ADDENDUM NO. CC-1

Millard Public Schools
Kiewit Middle School Office/Staff Lounge Renovation
Omaha, NE
BCDM Project No. 3026-09

BCDM Architects
1015 North 98th Street, Suite 300
Omaha, Nebraska 68114

June 11, 2013

SHEET E1-2, FLOOR PLAN - POWER

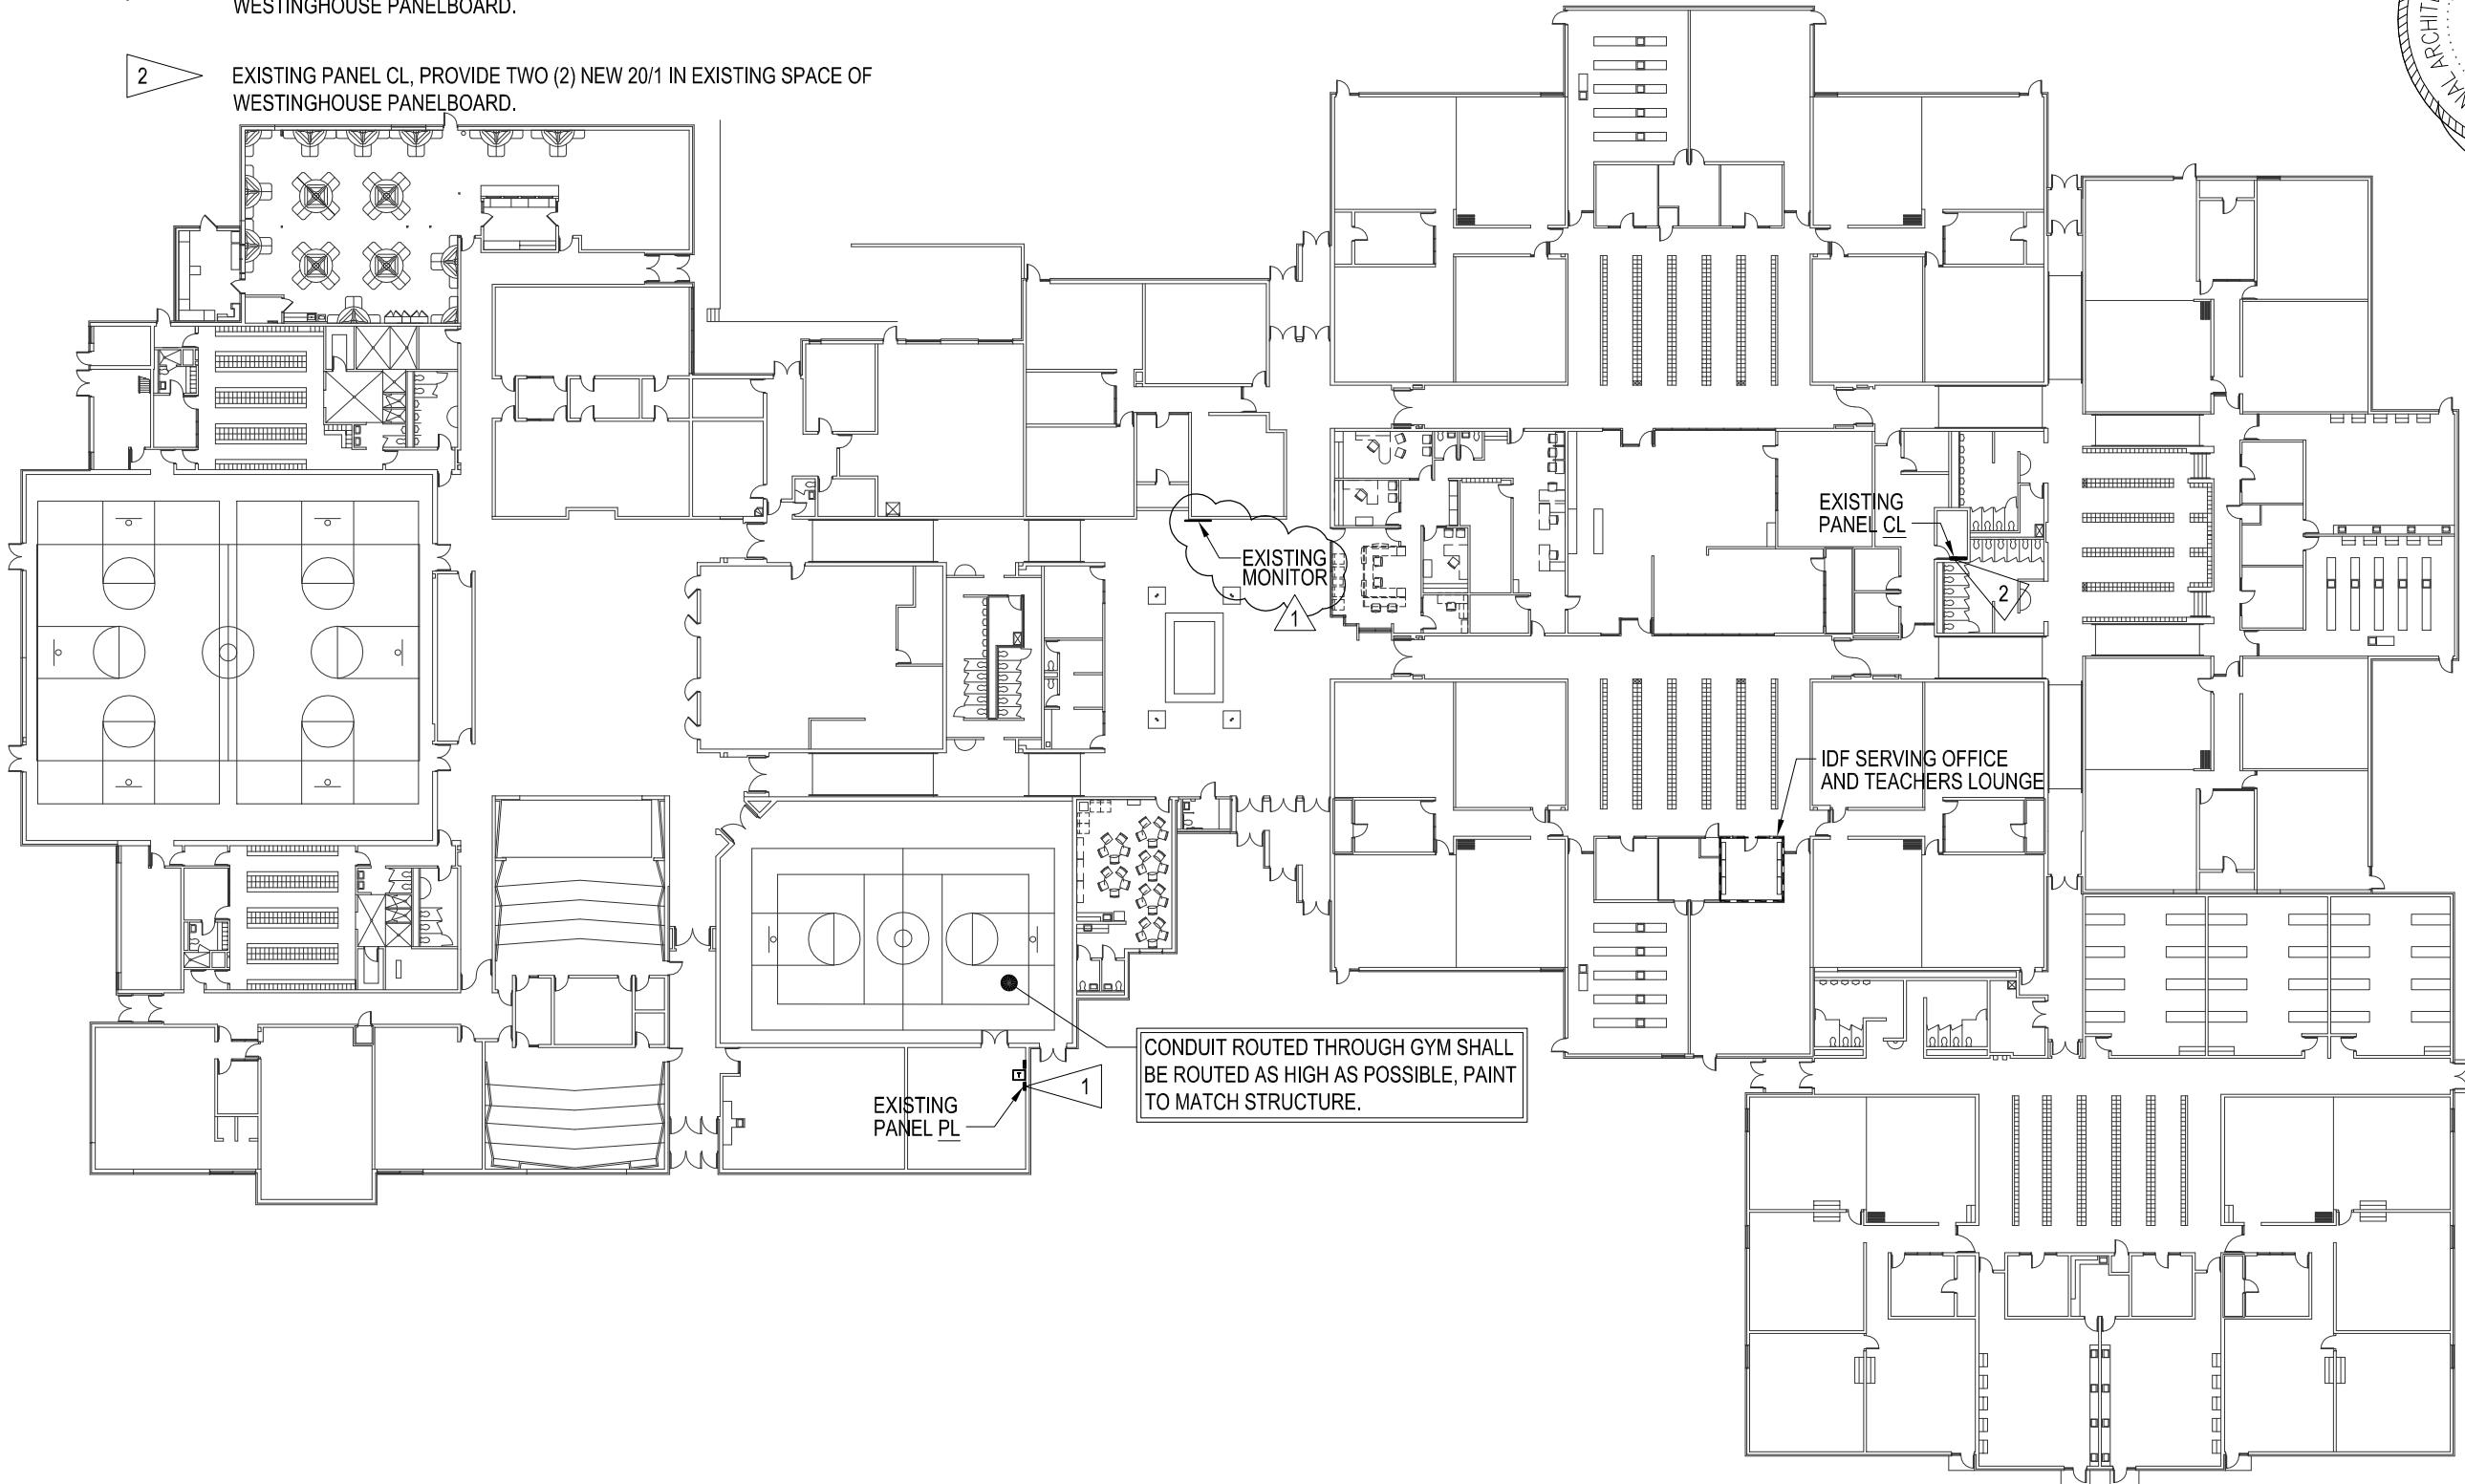
a. See attached revised power plan for modifications.
